Superfund Record of Decision:

Brewster Well Field, NY

REPORT DOCUMENTATION PAGE		1. REPORT NO. EPA/ROD/R02-88/063	2.	3. Recipient's Accession No.
4. Title and Subtitle SUPERFUND RECORD OF DECISION Brewster Well Field, NY Second Remedial Action - Final			5. Report Date 09/29/88

Enclosure

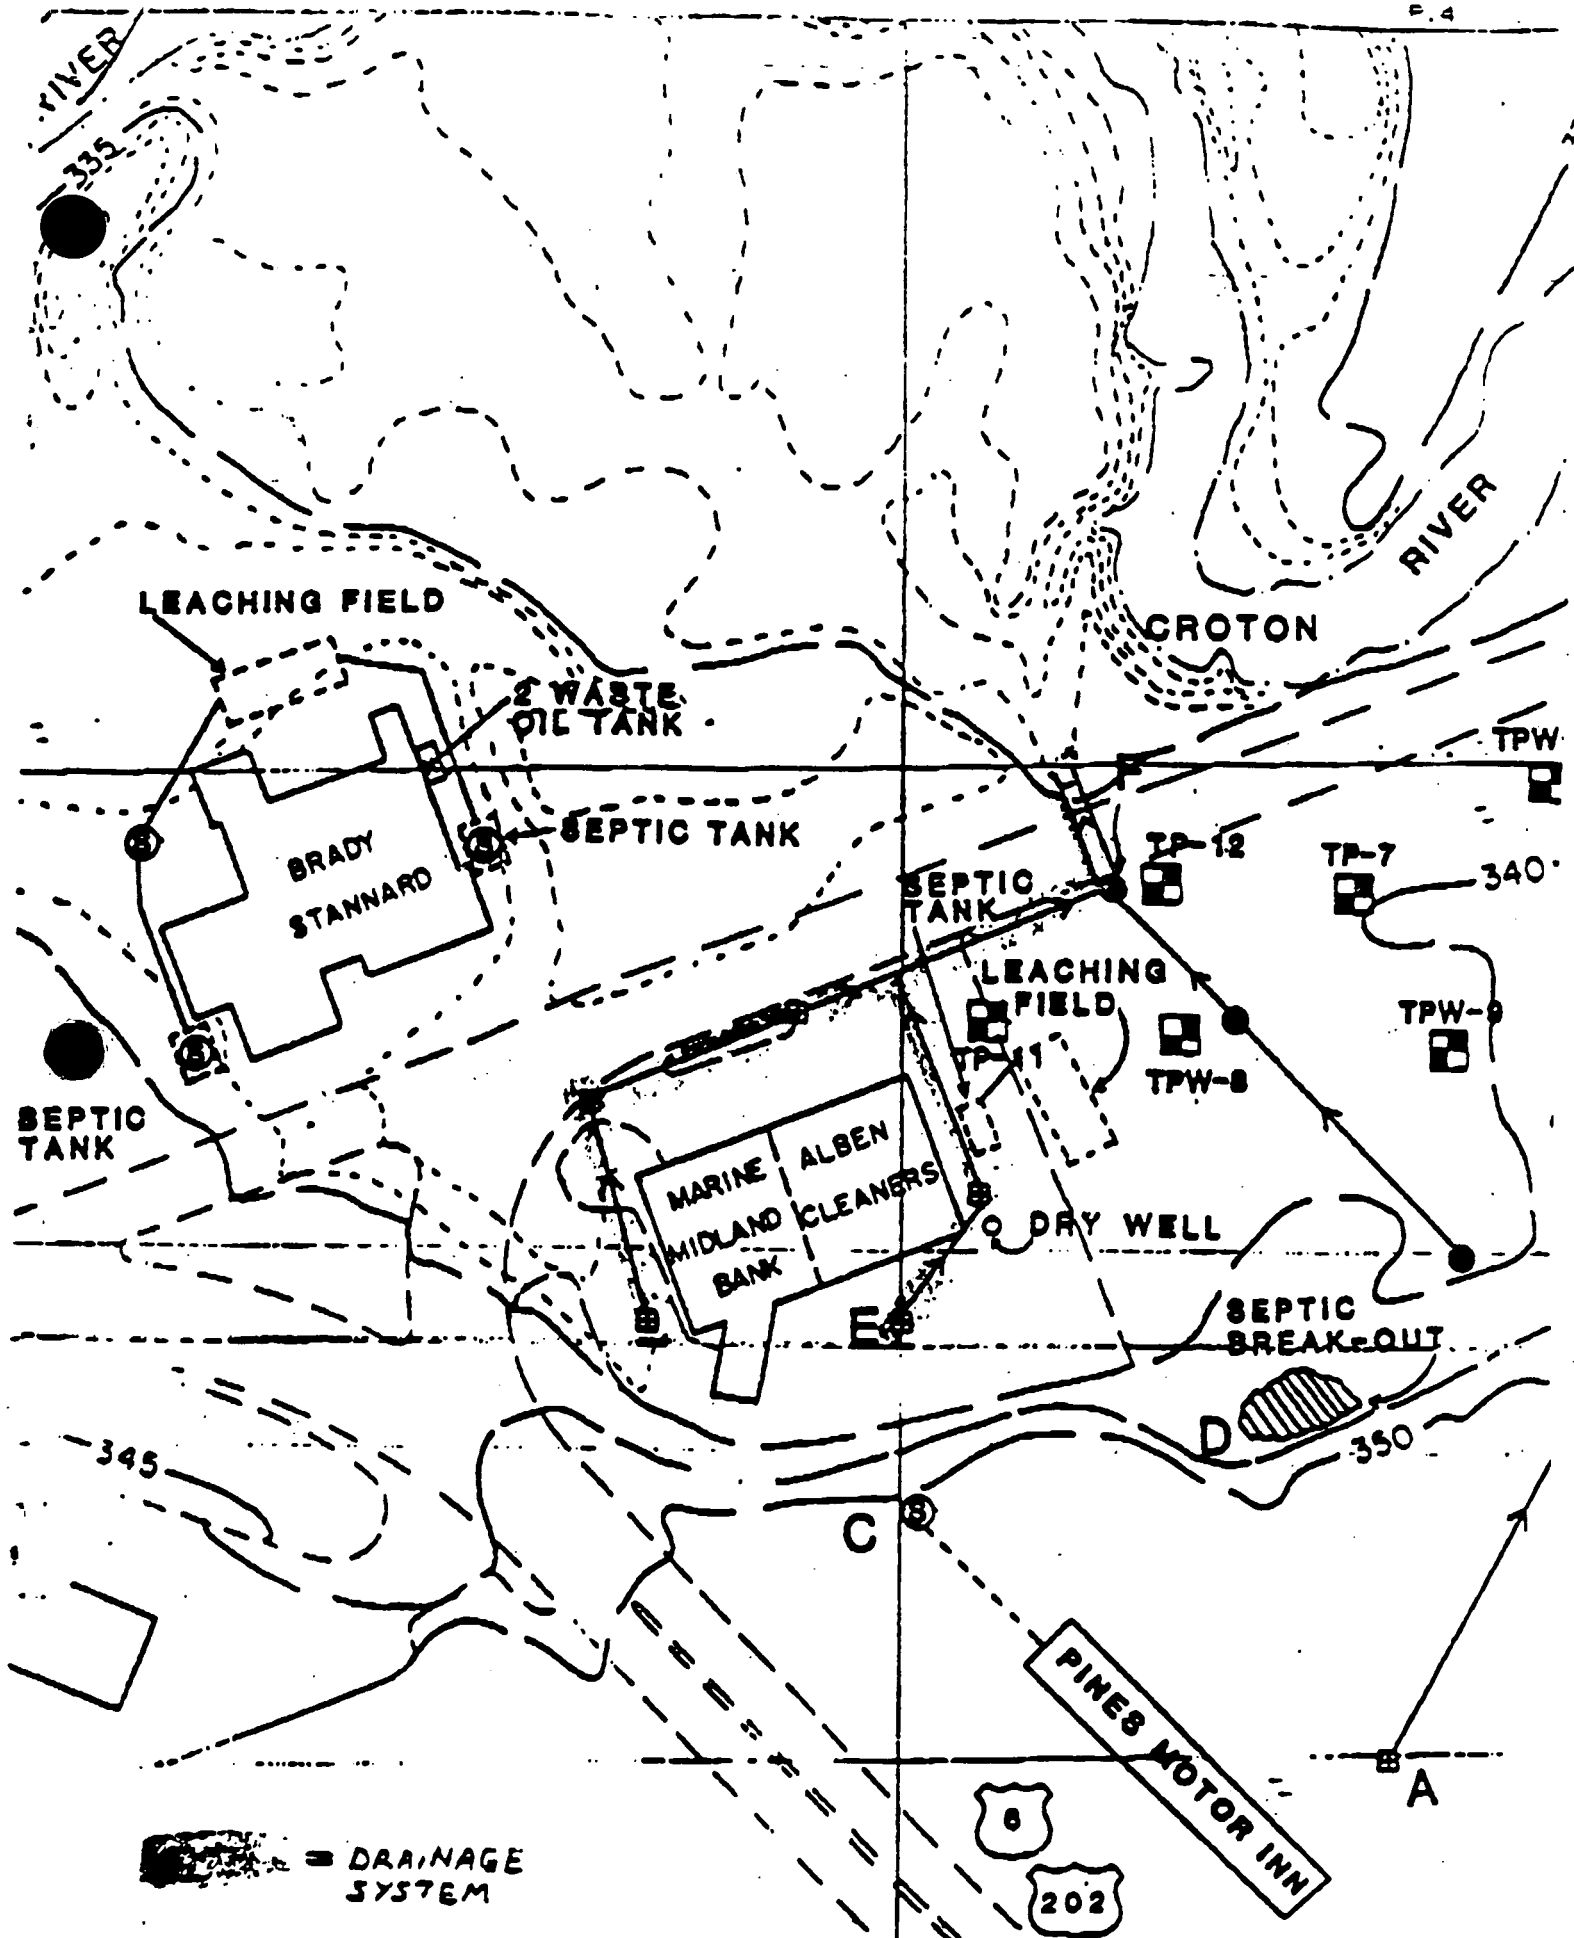
The draft Record of Decision (ROD) states, "Site soils and sediments, including those contiguous to the drywell and site drainage systems, will be tested during response actions, and those materials containing more than 4 ppm PCE (tetrachloroethylene) will be remediated." Please be aware that NYSDEC and the New York State Department of Health (NYSDOH) define this "drainage system" as one that begins at the catch-basins on site and continues through the culvert out-wash to the northeast of Alben Cleaners (see enclosure).
